RE: Zoning Commission Case No. 04-24
Rhode Island Avenue Metro, 2nd Stage PUD
Supplemental Plans and Information

At the September 11, 2006 meeting the Zoning Commission requested responses to a number of design and circulation issues to be addressed prior to setting the above-cited case down for public hearing. The applicant's design and consultant team has attempted to respond in detail to these requests, in the written responses below and in the attached civil, architectural and landscaping plans and exhibits to this transmittal letter.¹ At the September meeting, the Commission also invited the applicant to make a presentation to the Commission at the "setdown" meeting following submission of this material. The applicant would be pleased to avail itself of this opportunity.

EXHIBIT F – DIGITAL MASSING MODEL EXAMPLE

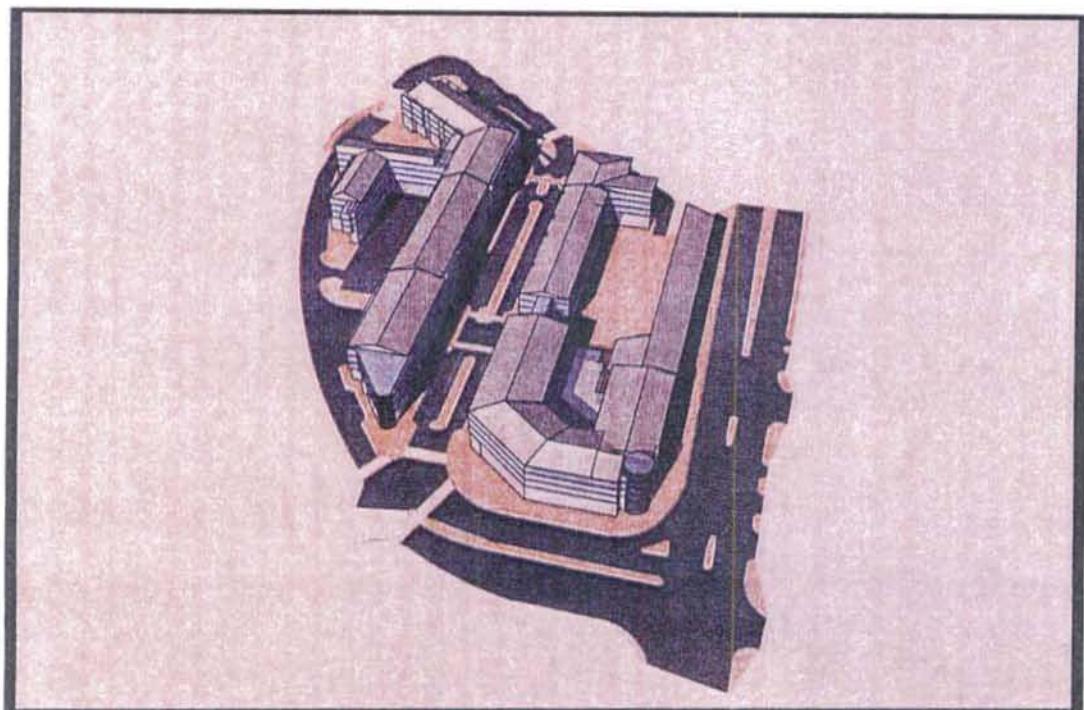
A. Digital Massing Model – Exhibit F is an example of a digital massing model shown from “Aerial” and “Medium Height” perspectives. We will provide these models from the following vantage points:

- Entering the site from Rhode Island Avenue (Rhode Island Avenue from the east)
- Rhode Island Avenue from the west
- The commuter road (along the southern perimeter of the site) from the west
- The commuter road from the east
- Main Street from the Metrorail platform (from the west)
- Main Street from the east

EXHIBIT G – DETAILED ILLUSTRATION EXAMPLE

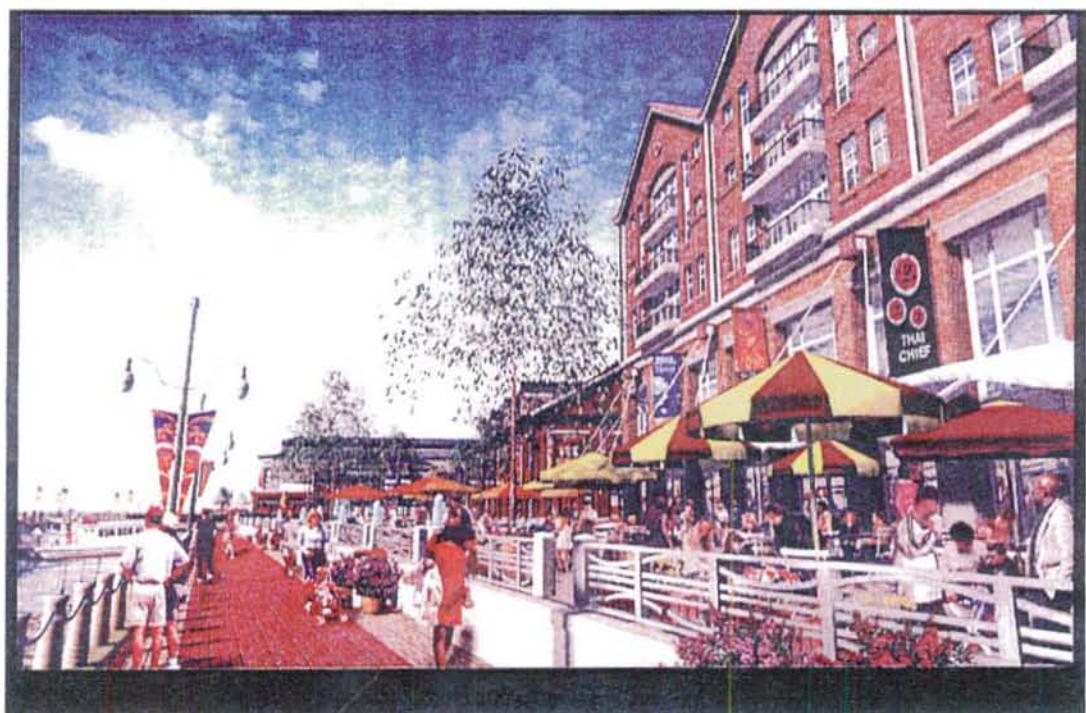
B. Detailed Environment Illustrations (Renderings) – Exhibit G is an example of a detailed environment illustration rendered at street level. We provide these from the vantage points listed above, as well as the following:

- Looking into the Building 1 amenity/pool area
- Turning left into the site (facing south)
- Standing in the middle of Main Street across the Garage 2 entrance
